North Yorkshire Council

11 October 2024

Oatlands Drive and Wetherby Road Crossing Upgrades

Report of the Assistant Director – Highways and Transportation, Parking Services, Street Scene, Parks and Grounds

Problem Location Plan Oatlands Drive

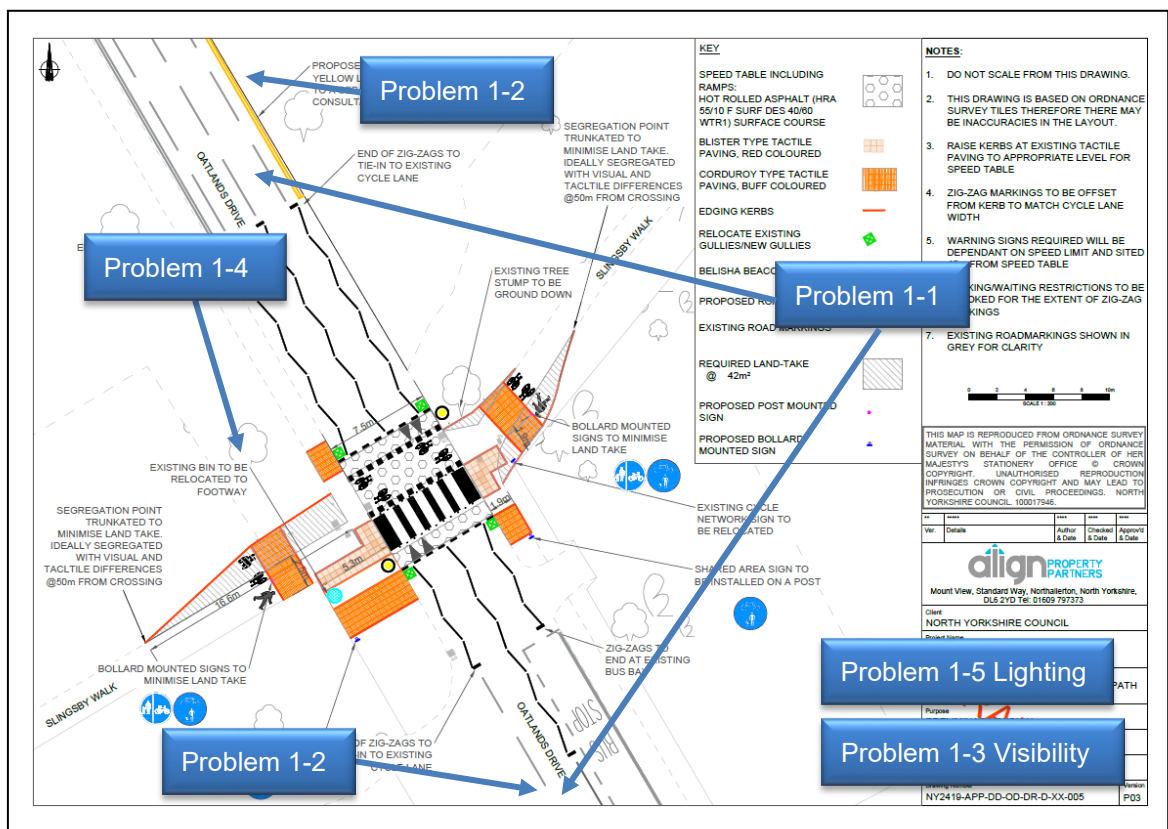
PROBLEM		1-2
Location:	Crossing approaches.	
Summary:	A lack of suitable signing will increase the risk of loss of control type collisions.	
<p>It is proposed to construct a raised controlled crossing with ramped approaches of up to 125mm. The Audit Team noted that there are no warning signs proposed on the approaches to the crossing location.</p> <p>A lack of suitable signing will increase the risk of loss of control type collisions.</p>		
RECOMMENDATION		
At detailed design ensure that warning signs are provided on the approaches.

PROBLEM		1-3
Location:	Crossing approaches.	
Summary:	A lack of suitable cycle-vehicle visibility splays can increase the risk of cycle-vehicle collisions.	
<p>As part of the scheme, it is proposed to construct a new controlled crossing. The Audit Team did note that visibility splays are not shown on the drawings. LTN 1-20 Table 5-6 states that the minimum "X" distance is 2.4m and the Stopping Sight Distance should be based on Manual for Streets.</p> <p>A lack of suitable cycle-vehicle visibility splays can increase the risk of cycle-vehicle collisions.</p>		
RECOMMENDATION		
Provide unobstructed visibility splays at the crossing.

PROBLEM		1-4
Location:	Crossing western side.	
Summary:	Overhanging vegetation will result in head strikes to cyclists causing injury.	
<p>It was noted during the site visit that there is a large tree on the western side of the crossing just to the north of where the cycle route will be widened on the approach to the new crossing.</p> <p>The Audit Team considered it highly likely that overhanging branches will result in an increased risk of head strikes to cyclists.</p>		
RECOMMENDATION		
Crown lift the tree ensuring that 2.4m of head height is provided and also ensure that maintenance of the tree is undertaken on an annual basis to ensure that a minimum of 2.4m is provided.

PROBLEM		1-5
Location:	Crossing approaches.	
Summary:	Sub-standard lighting levels will increase the risk of darkness collisions between Vulnerable Road Users and vehicles.	
<p>It was noted during the site visit that there are only two lighting columns near the proposed crossing location. The first is to the south of the crossing point and the second to the north, both columns are on the western side of Oatlands Drive.</p> <p>Due to the large trees located along Oatlands Drive there is a concern that the existing lighting will not be sufficient for the new crossing and as such will increase the risk of darkness collisions between Vulnerable Road Users and vehicles.</p>		
RECOMMENDATION		
At detailed design undertake a lighting check at the new crossing to ensure that the current lighting will be sufficient for the new crossing.

Problem Location Plan A661 Wetherby Road

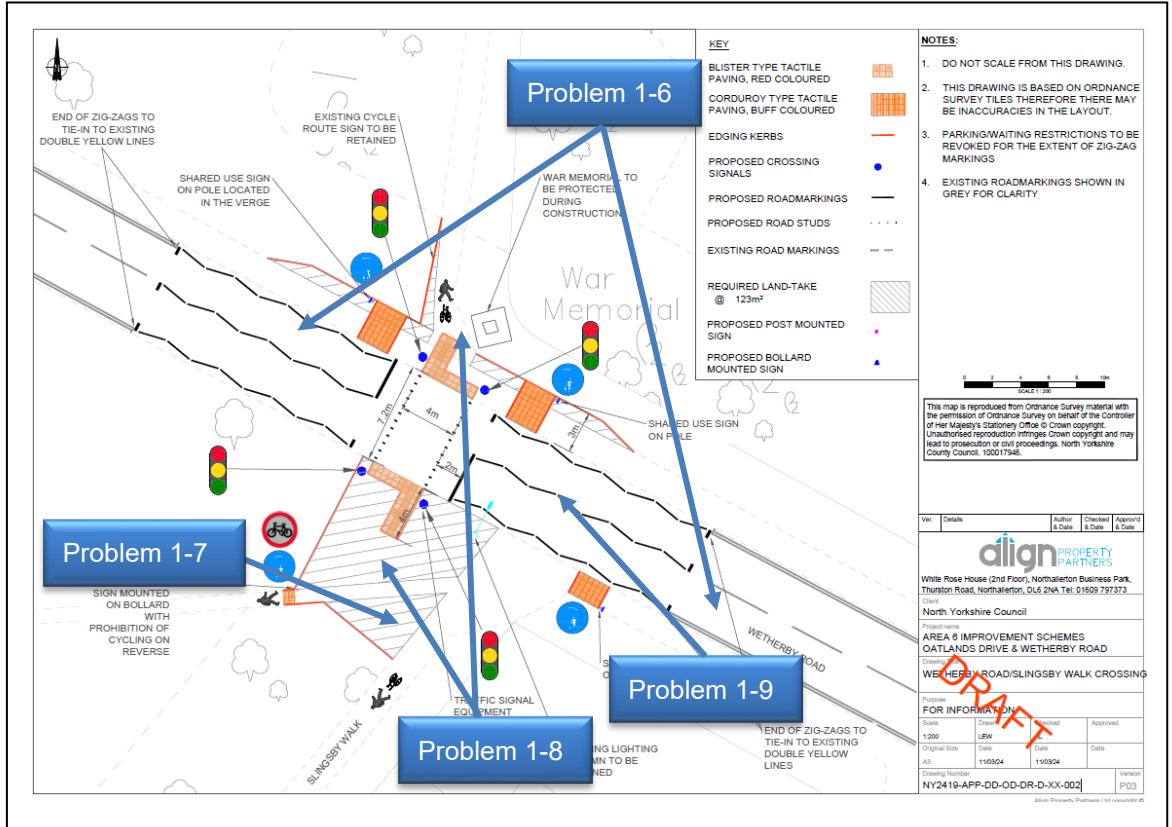
Extend the tactile paving.

PROBLEM		1-9
Location:	A661 Wetherby Road.	
Summary:	Retained uncontrolled crossings will increase the risk of pedestrian/vehicle and vehicle/vehicle collisions.	
<p>The drawings do not show that the existing uncontrolled crossing on Wetherby Road to the south of the new crossing will be removed. Having a new Toucan crossing and existing uncontrolled crossing in such close proximity will be both confusing for pedestrians/cyclists and motorists leading to an increased risk of pedestrian/vehicle and vehicle/vehicle collisions.</p>		
RECOMMENDATION		
Remove the existing uncontrolled crossing.
